**City of  
Richmond**

**Report to Development Permit Panel**

**Re:** **Application by IBI Group Architects (Canada) Inc. for a Development Permit at  
9520 Beckwith Road**

# Level 05 - Floor Plan

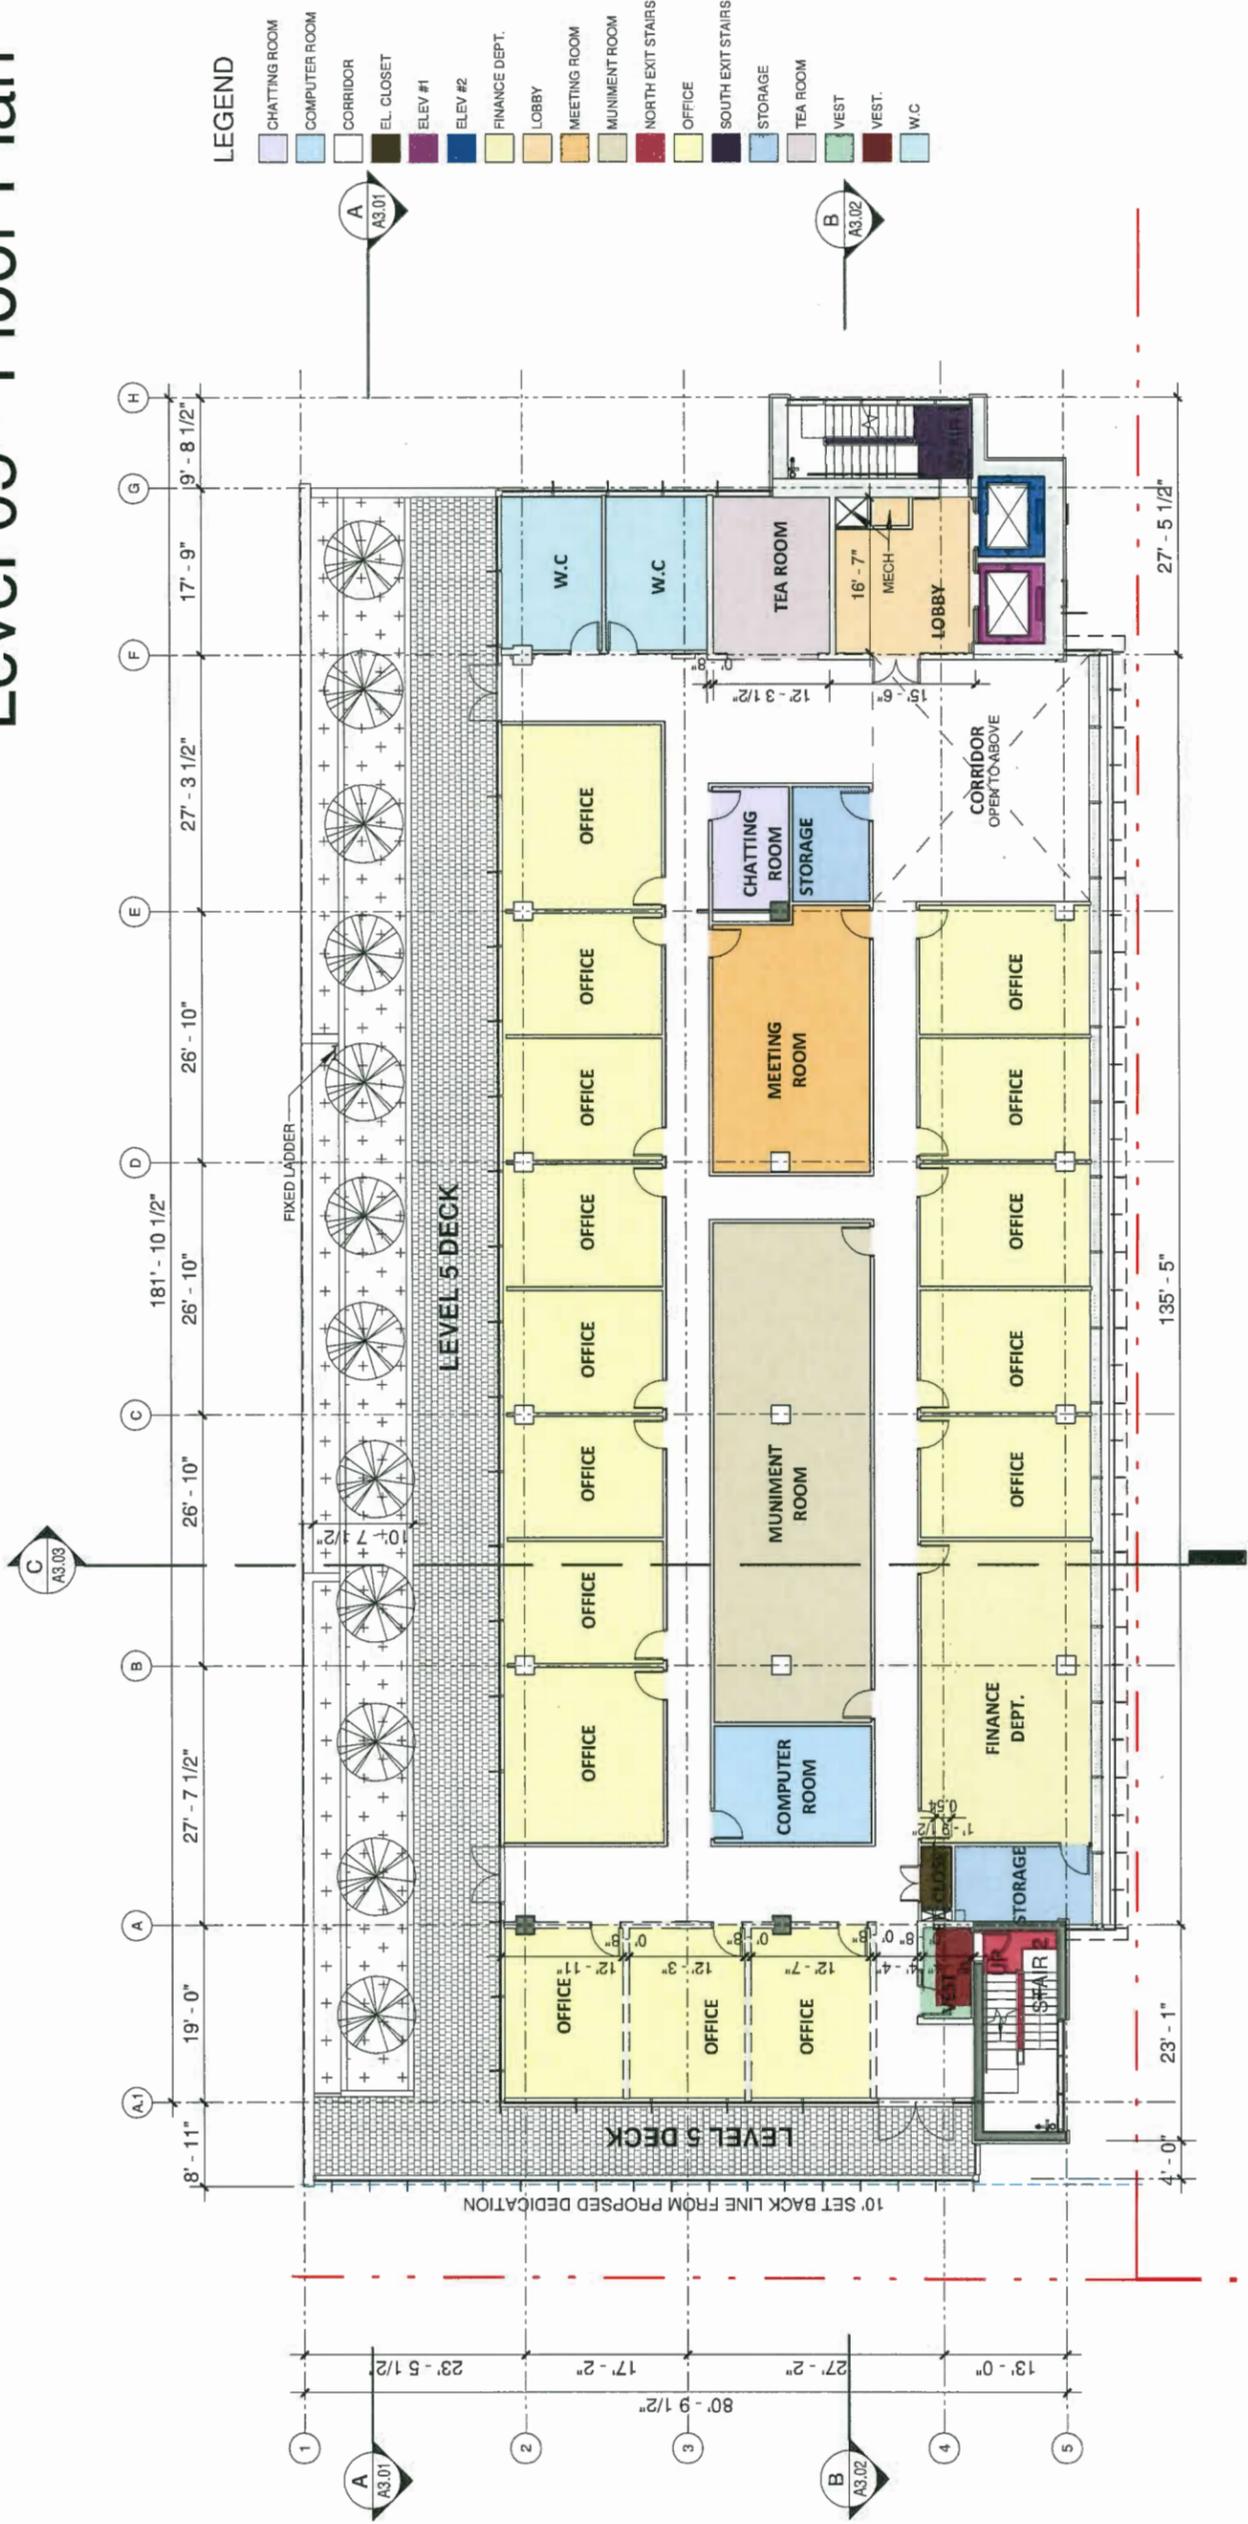
- appreciate the amount of planting in the project and extensive use of native species; concerned on vine planting below Level 5 which is not shown on the planting plan for Level 5 as it is technically not on Level 5; applicant needs to consider provision of maintenance access; ***IBI: Guardrail access will be provided to maintain step-down planter. A fixed ladder is shown on A1.05 (at Gridline L1 between Gridlines D/E).***

- support the Panel comment regarding the lack of provision for maintenance access for vines on the lower planter below Level 5; consider installing a permanent ladder structure on the outside to connect the higher Level 5 planter to the lower planter;

***IBI: Guardrail access will be provided to maintain step-down planter. A fixed ladder is shown on A1.05 (at Gridline L1 between Gridlines D/E).***
- programming on the building rooftop could be enhanced; consider breaking up the 20-foot long planting bed into smaller beds as it is difficult to maintain; the applicant could use the freed space for other uses that would benefit office space users; ***IBI: A break in the landscaping was made.***

Drawing #: L-02A  
 VZ Project #: DP2018-29  
 Drawing Title: SITE PLAN - LEVEL 1

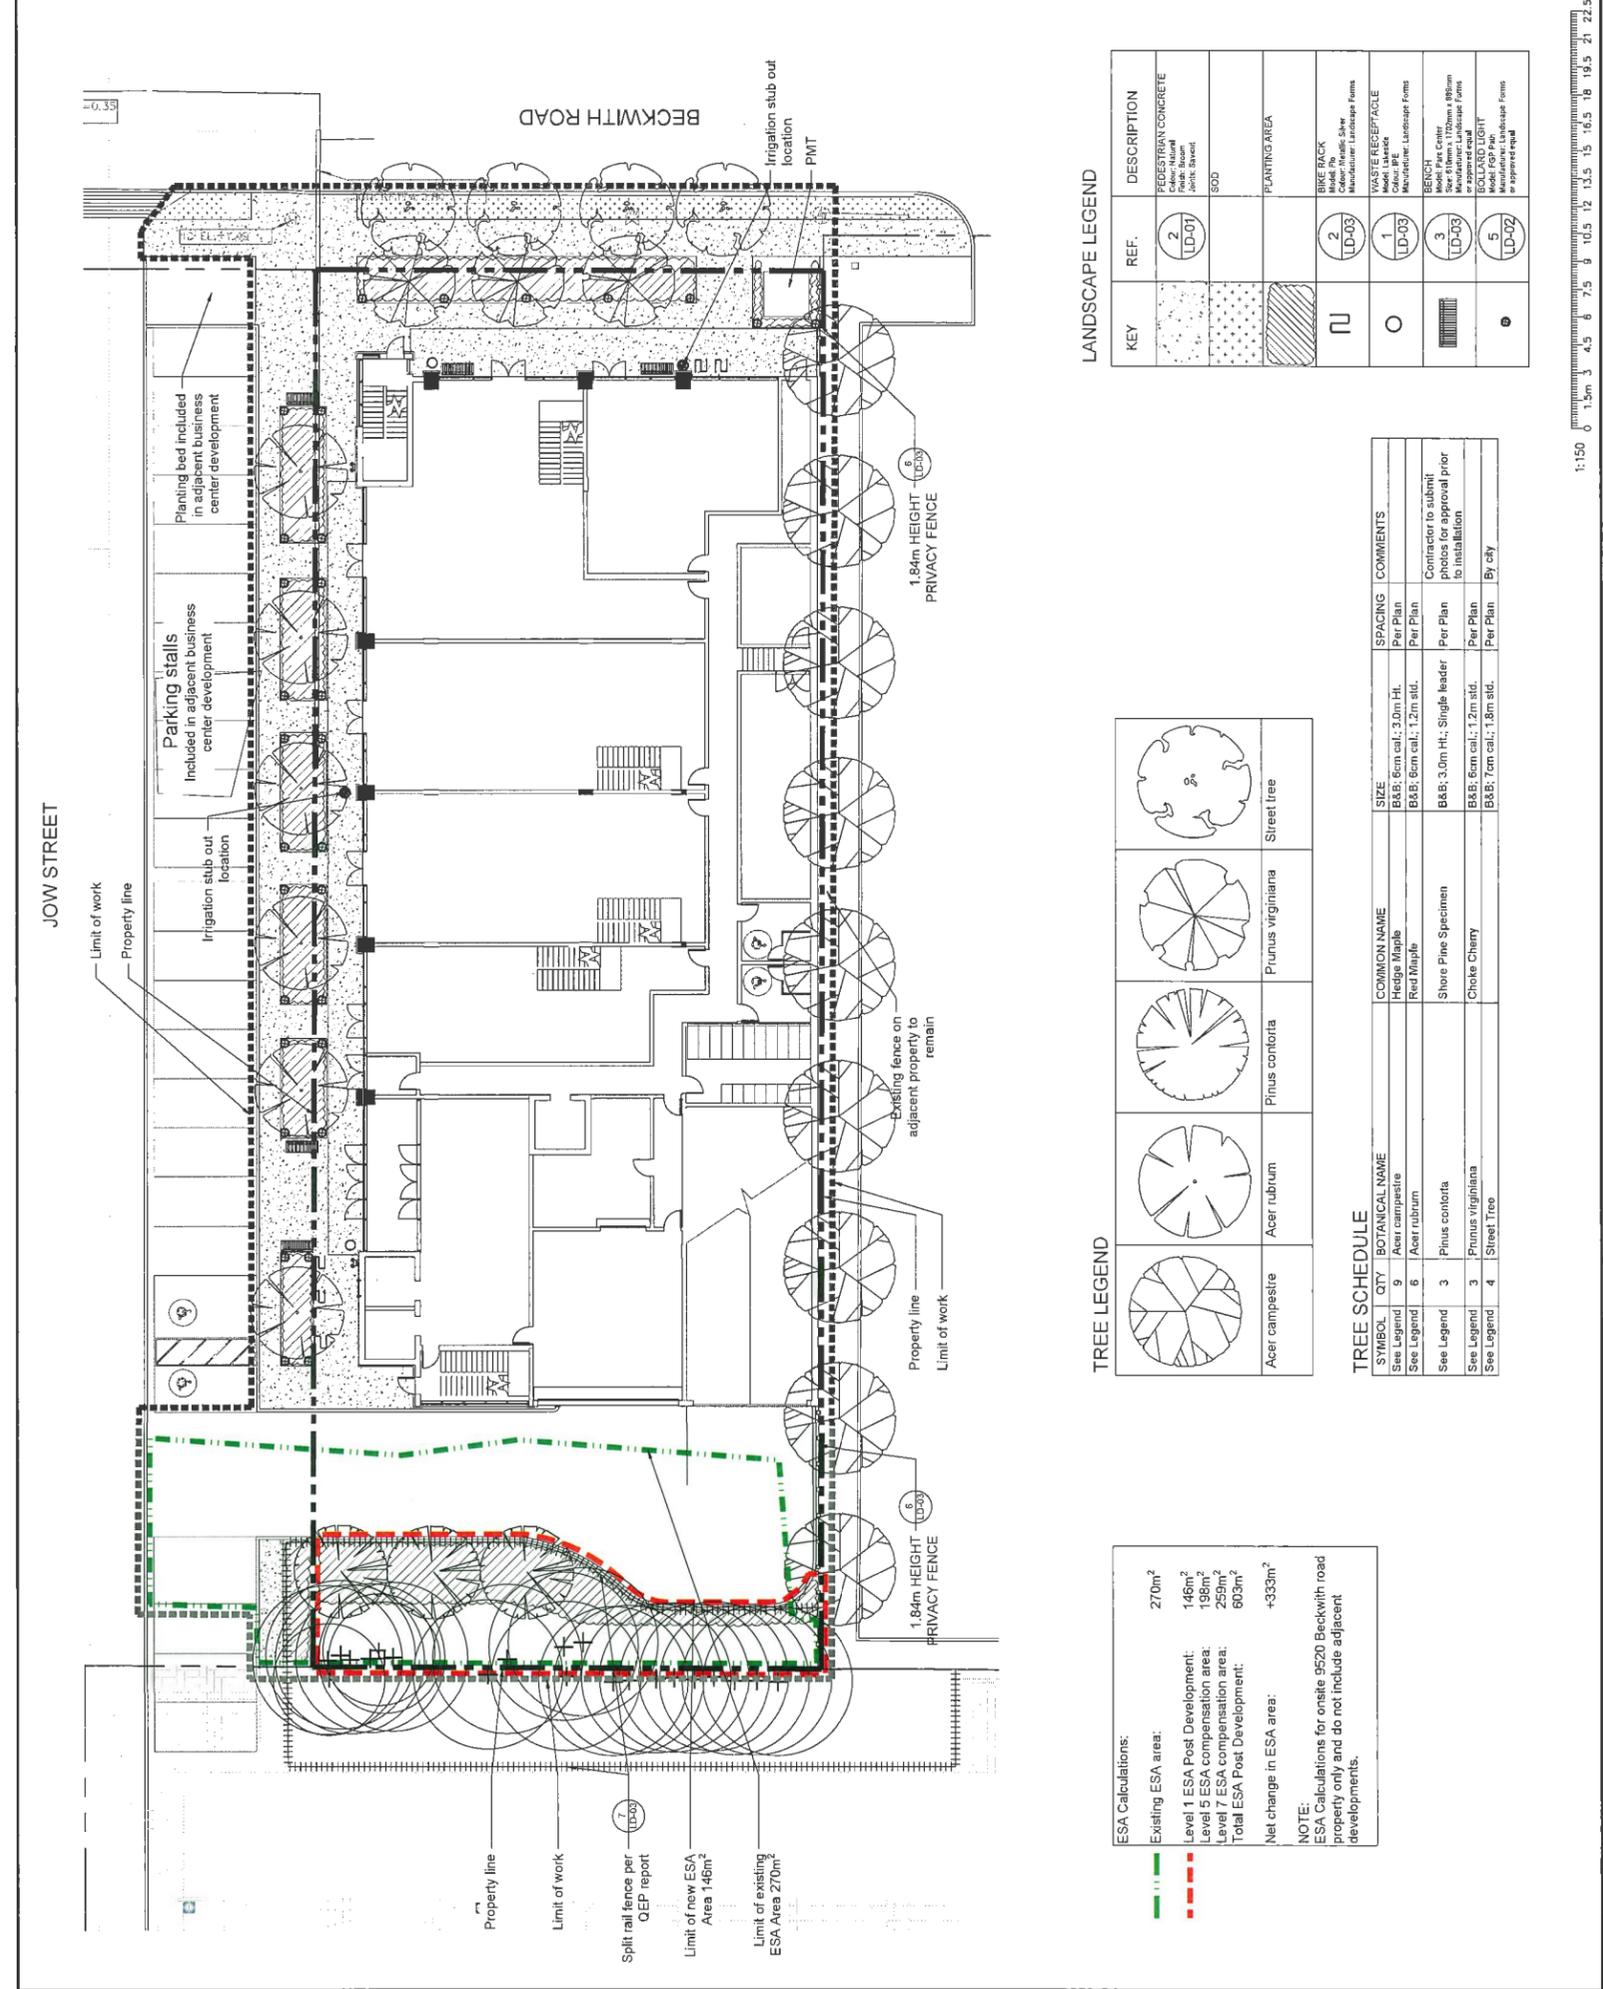
- appreciate the high density of tree planting and landscaping along the building's Beckwith Road frontage to provide a buffer to the existing single-family homes to the north; however, consider opening up the landscaped area along the north edge of the site to provide additional pedestrian access to the building from the north and address potential CPTED concerns; ***IBI: Landscaping at North elevation, along Beckwith road, was revised accordingly, to open up the elevation and introduce additional pedestrian connection. See A0.09 and L-02A***

- support the proposed bollard lighting along the west and north sides of the building;
- consider introducing landscaping around the Pad Mounted Transformer (PMT) fronting Beckwith Road to screen it from pedestrian view; ***IBI: Green hedge was added around PMT, to create aesthetic concealment. See A0.09 and L-02A.***

- consider adding lighting to the loading area on the south side of the building to enhance pedestrian experience and safety at night; ***IBI: Upward accent lights and flood lights were added to increase illumination, accentuate the trees, along South elevation. See L-02A.***

- shadow study shows that the north elevation is a dark space most of the time; high density of planting including trees, native shrubs and planters along the Beckwith Road frontage will pose sightline issues; consider keeping the planting low and open up some of the trees to allow more sunlight; ***IBI: Landscaping at North elevation was revised accordingly, to allow more sunlight in. See A0.09 and L-02A***
